Access Compliance Report

Public Rights-of-Way

(Curb Ramps)

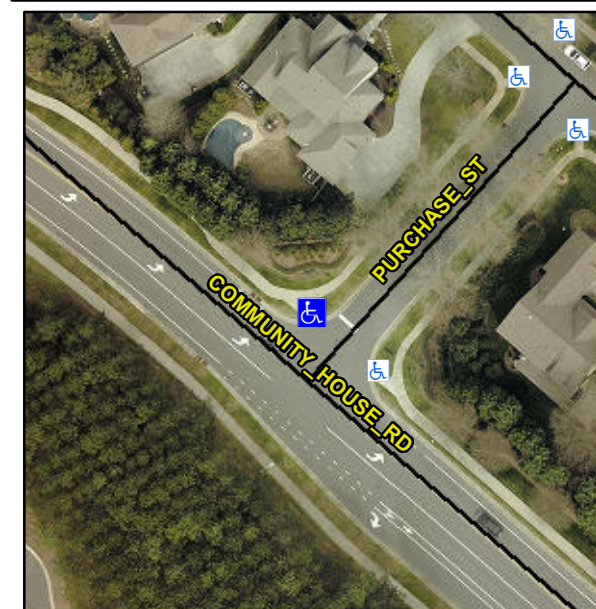
Intersection ID: 28279	Main Street: COMMUNITY_HOUSE_RD	Cross Street: PURCHASE_ST	Location: N
ADA ID: 2E91C972807E	Ramp Type: Directional1	Initial Pass/Fail: Fail	Overall Compliance: No
Severity Score: 12.5			
Codes/Mitigation Info/Possible Solution		Field Measurements/Component Compliance

R304.2.2

Remove & Replace Entire Ramp.
